**Application For Alternate Material,
 Design, or Method of Construction**
 Deviation Request Per 2019 Development Standards Section 1.5

**Williams Invest -
Third and Park**
FOR
**5J WILLIAMS
FAMILY LLC**
AT
**3RD & PARK AVE
MUKILTEO, WA 98275**

**FLOOR PLAN - PARKING
LEVEL**

A1.10

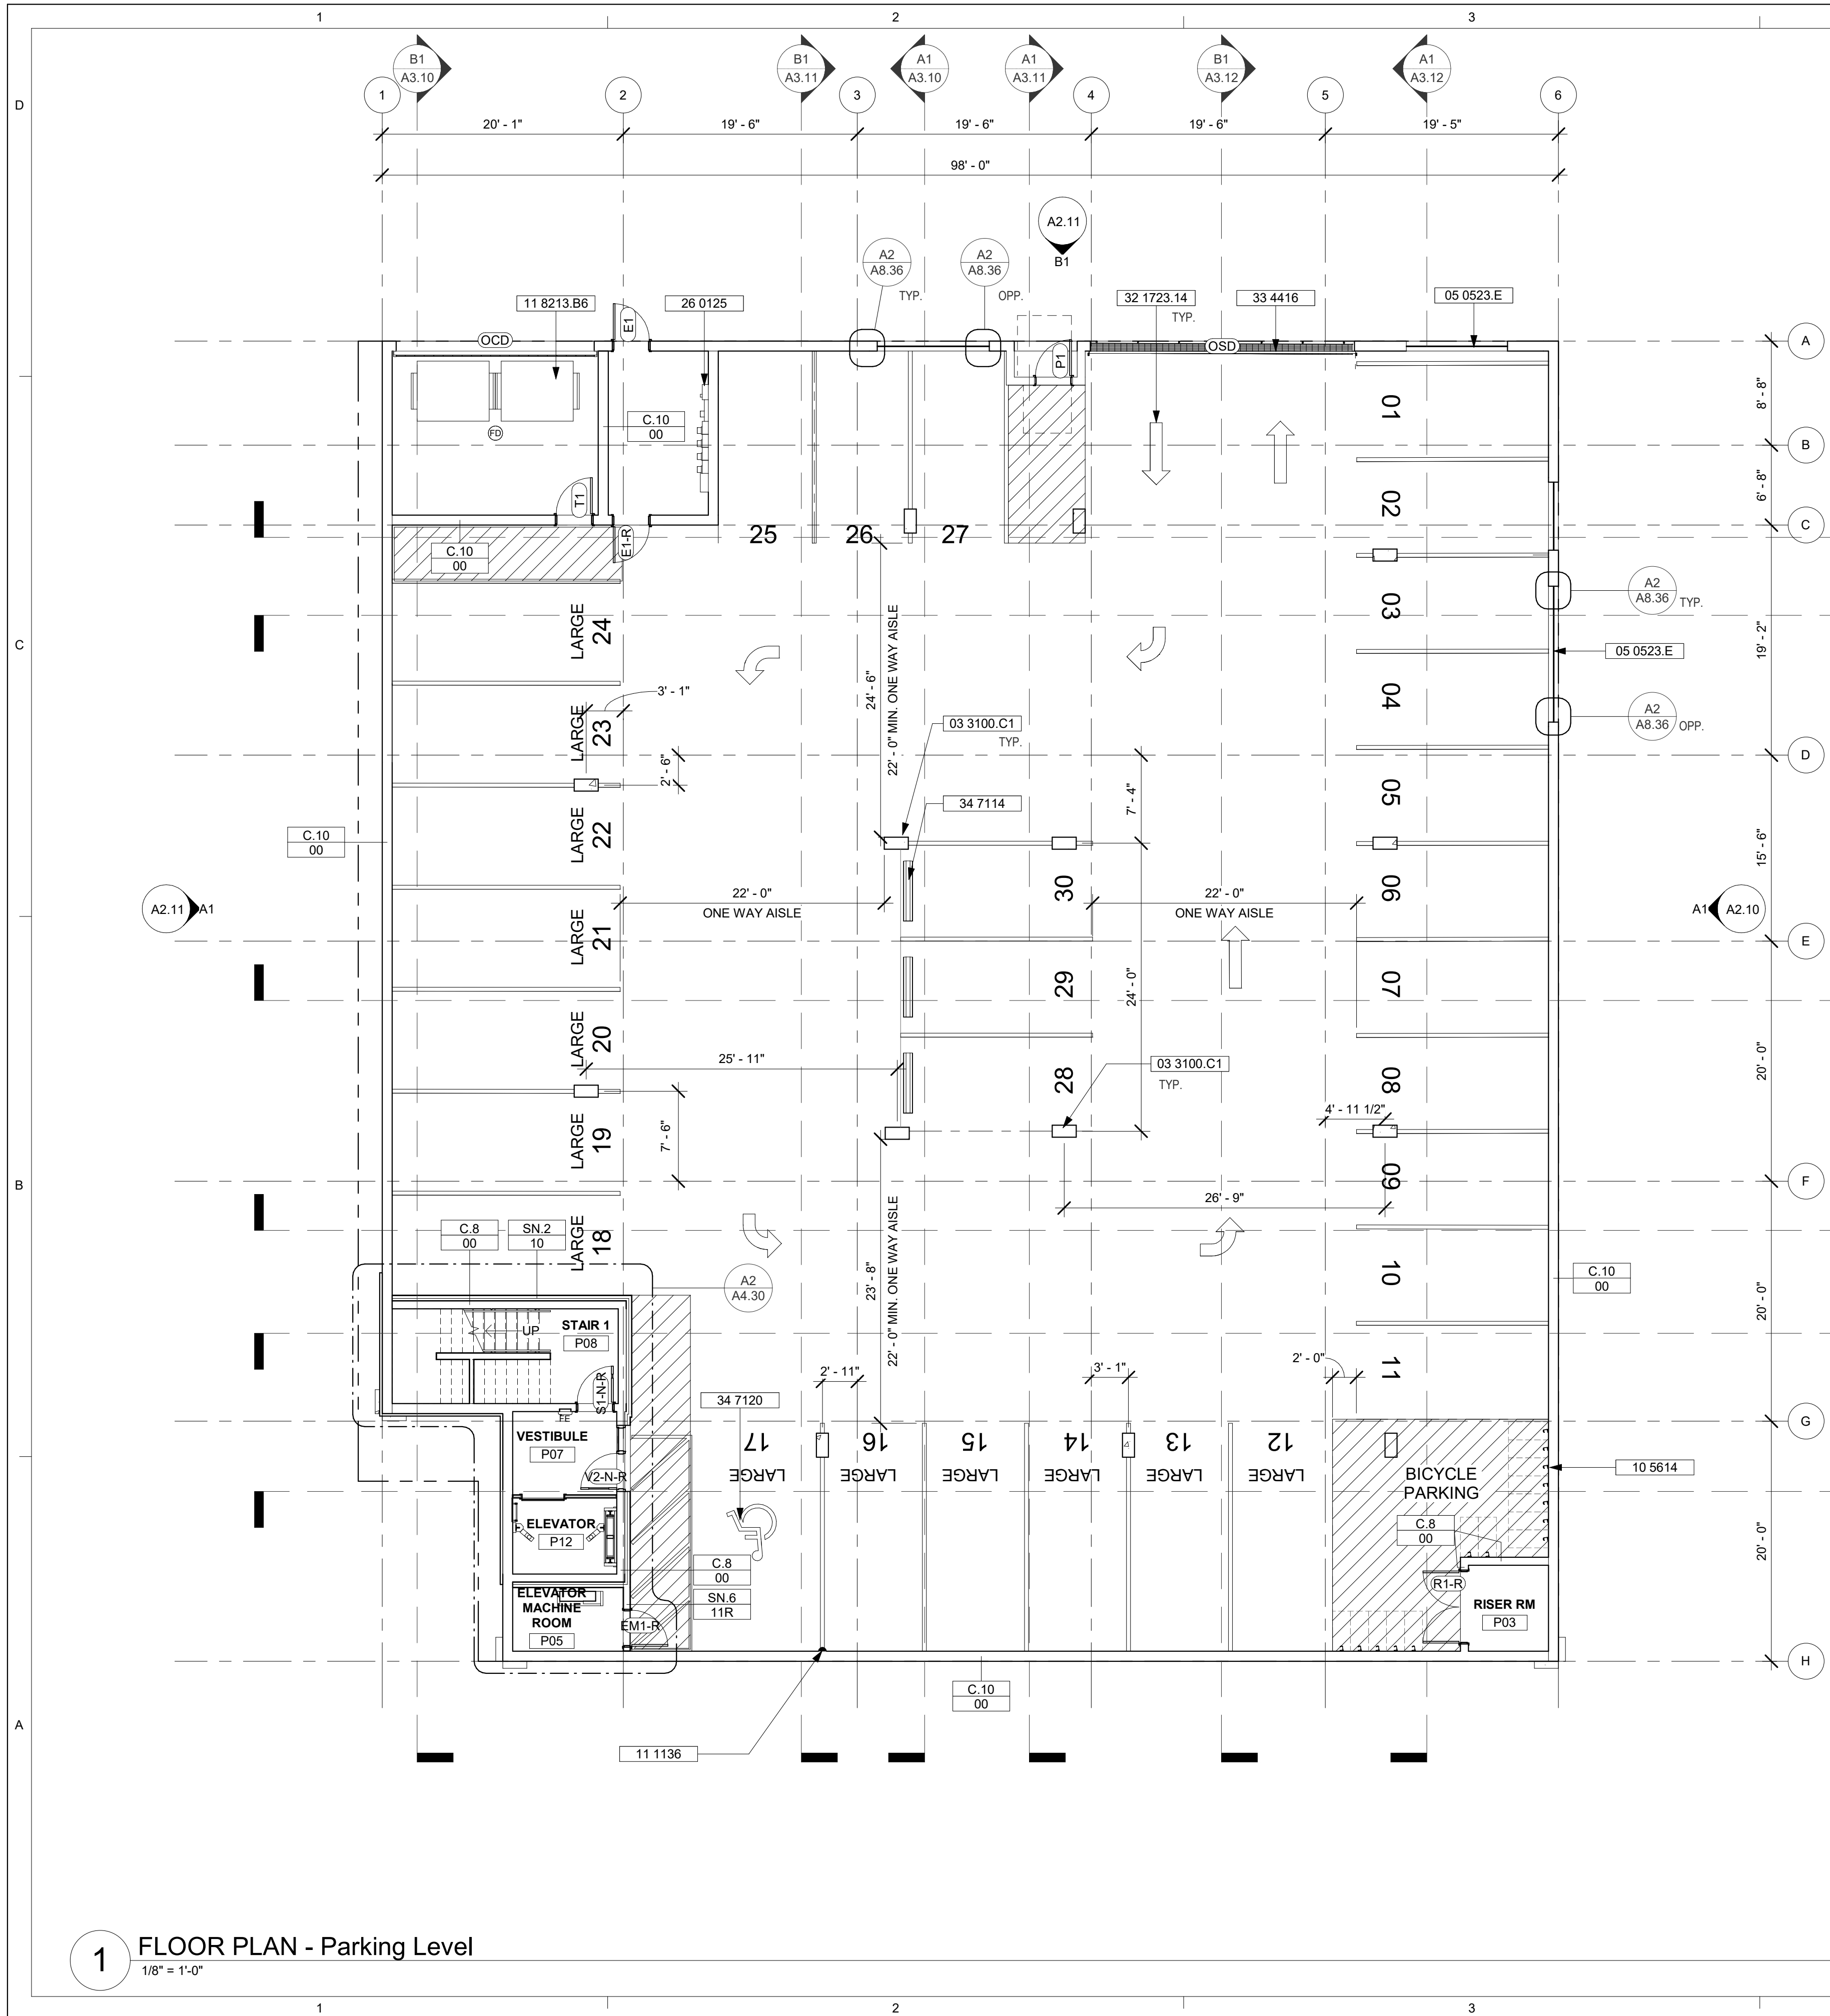
We are requesting a variance from standard parking and driving lane sizes within the project Parking Garage on Level P1 (accessed from the alley). We believe that the sizes we show on Drawing A1.10 reflect realistic sizes for Structured Residential parking. Whereas the city standards reflect more appropriate sizing for on grade short time parking. The 30 parking spaces shown on Drawing A1.10 is for a Parking Garage for residents of the 14 units of the Mixed Use project. Of these, 1 stall is ADA van: 9'x'19' (with 5' wide adjacent access aisle), 17 stalls are medium size vehicles: 8'x16', and 12 are large size vehicles: 8'-6"x19'. We looked at Seattle Municipal Code section 23.54.030 (excerpt attached) which provides the definitions of medium and large size vehicle stalls. We feel that the SMC sizes more closely align with the intent of the Structured Garage parking.

MMC 17.56.100 specifically refers to 'off street parking' but does not address Structured Parking, which is very different. We believe Seattle Municipal Code sizes better suit the parking environment in a gated residential garage setting. We also feel that our aisle sizes are suitable for Structured Parking, though slightly smaller than MMC 17.56.100 prescribes.
